## Staff Report to the Western Weber County Planning Commission

<b>Application Request:</b>	Consideration and action on a request for approval of an Alternative Access Exception and preliminary approval of Warren Estates Subdivision consisting of 7 lots.
<b>Type of Decision:</b>	Administrative
<b>Agenda Date:</b>	Tuesday, November 16, 2021
<b>Applicant:</b>	Derrick Oman, Owner
<b>File Number/s:</b>	AAE 2021-12 & LVW090821

<b>Approximate Address:</b>	550 N. 5500 W. Unincorporated Weber County
<b>Project Area:</b>	10.131 acres
<b>Zoning:</b>	Agricultural (A-2)
<b>Existing Land Use:</b>	Agriculture
<b>Proposed Land Use:</b>	Residential
<b>Parcel ID:</b>	15-024-0004
<b>Township, Range, Section:</b>	T6N, R2W, Section 7 SE

**STREET SECTION PRIVATE ACCESS EASEMENT**  
SCALE: NONE

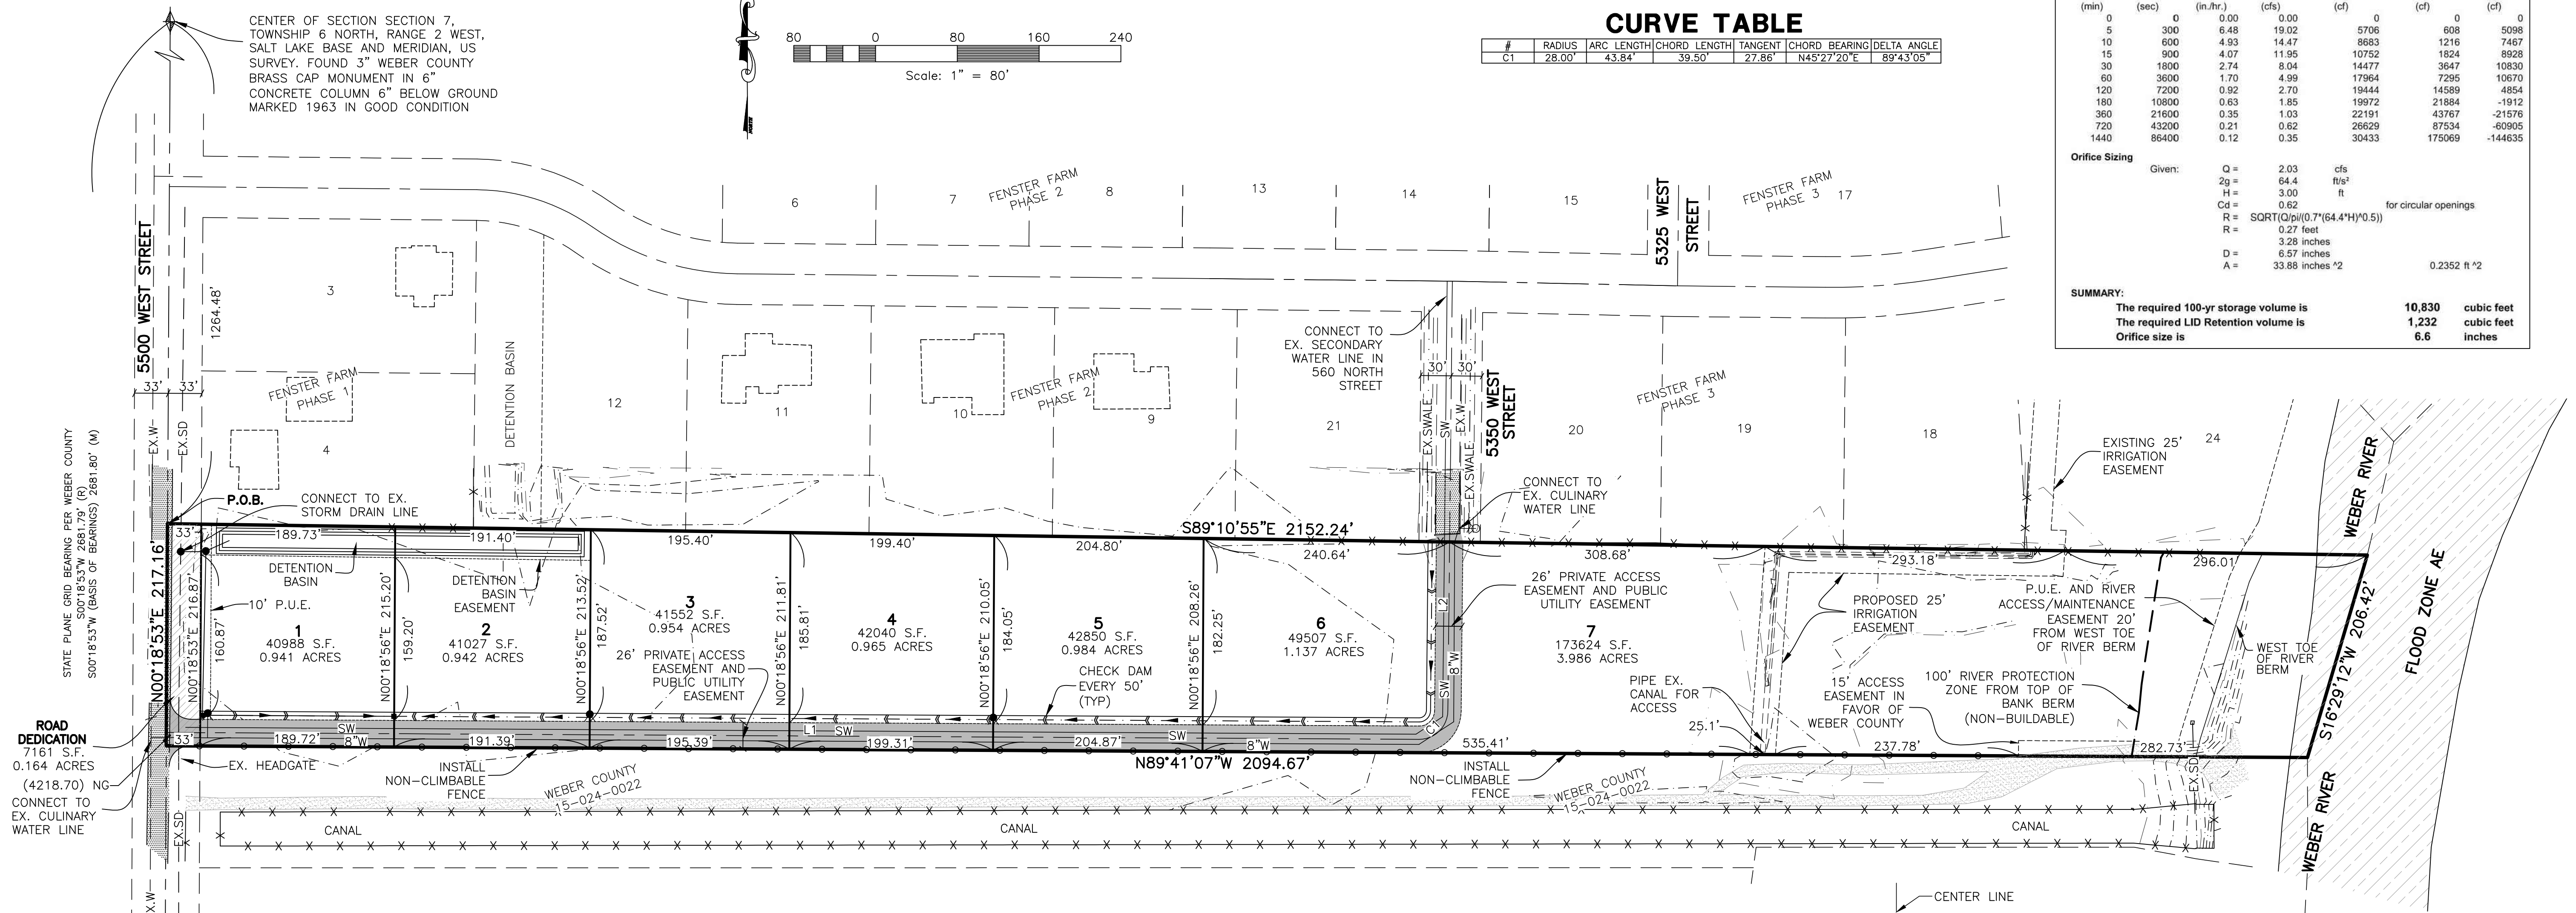
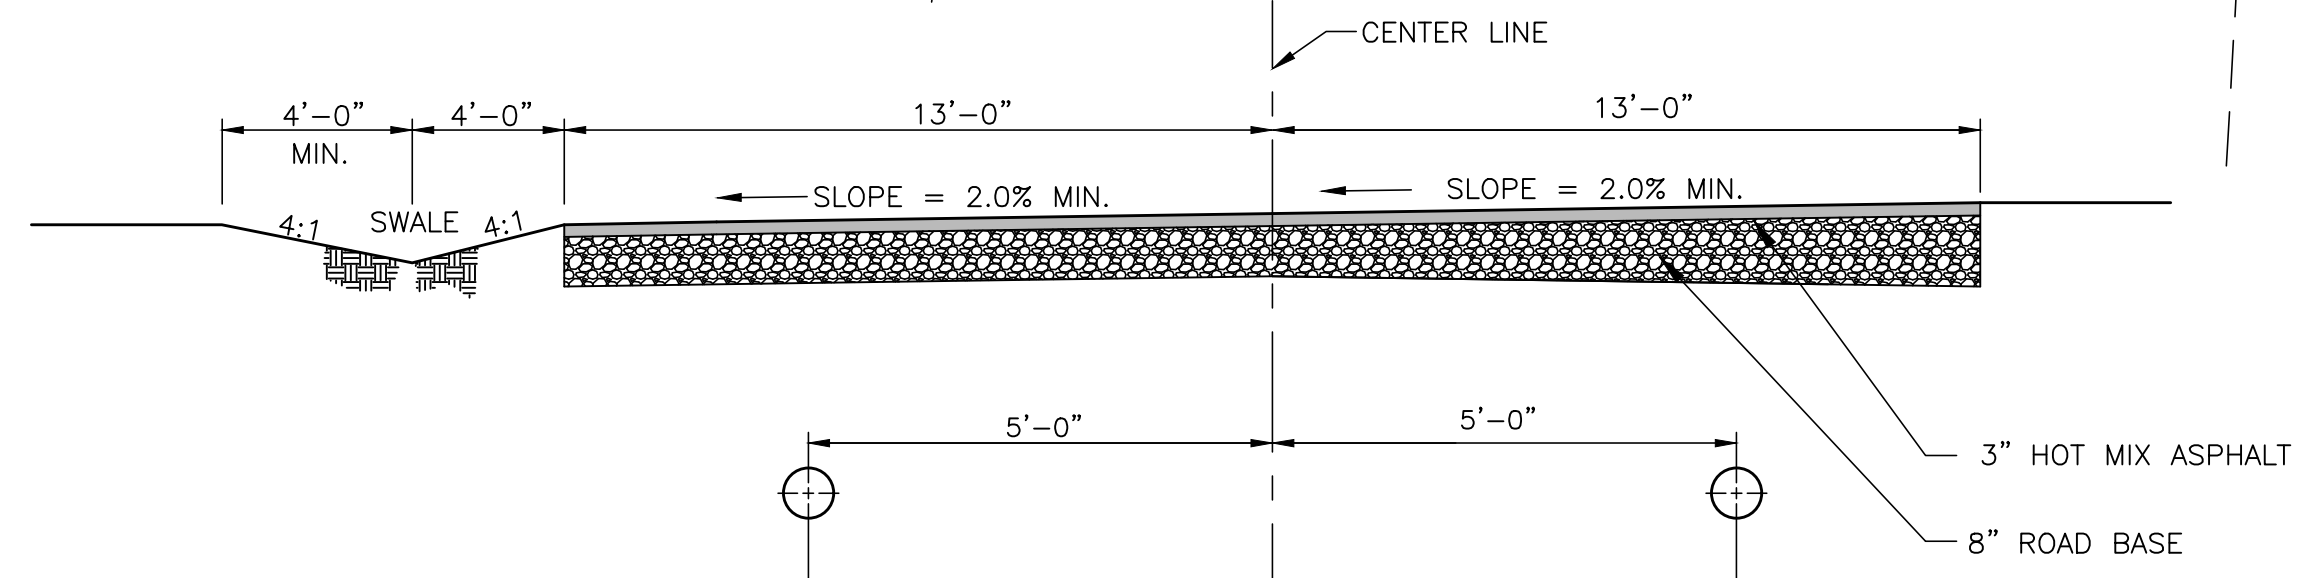
In reviewing the alternative access exception application, the Fire Marshal requested that the access easement be widened to 26 feet and be engineered to support 75,000 lbs. of weight. This configuration has been accommodated on the proposed subdivision plat.

As a condition of final approval, the Engineering Division have requested to have the southern boundary of the subdivision fenced with a no-climb fence to protect the adjacent Weber River flood channel. This fence line is shown on the proposed plat document.

As a condition of final approval, the Fire Marshal has asked that there be no parking along at least one side of the access easement. Planning staff recommend that no-parking signs be installed along the no-climb fence that will be installed along the southern boundary line. The fire marshal has also indicated that fire hydrants will need to be installed at a spacing of no more than 500’ apart. These hydrants will need to be installed or escrowed for prior the recording of the final plat mylar.

3. No-parking signs shall be installed along the no-climb fence along the southern boundary line.
4. Fire hydrants will need to be installed at a spacing of no more than 500' apart. These hydrants will need to be installed or escrowed for prior the recording of the final plat mylar.

5. The proposed 26-foot wide access easement will need to be improved to the access standards of LUC Sec. 108-7-29 or escrowed for prior to the recording of the final plat mylar.

9. A no-climb fence along the southern boundary of the subdivision to protect the adjacent Weber River flood channel will need to be installed or escrowed for prior to recording the final plat mylar.
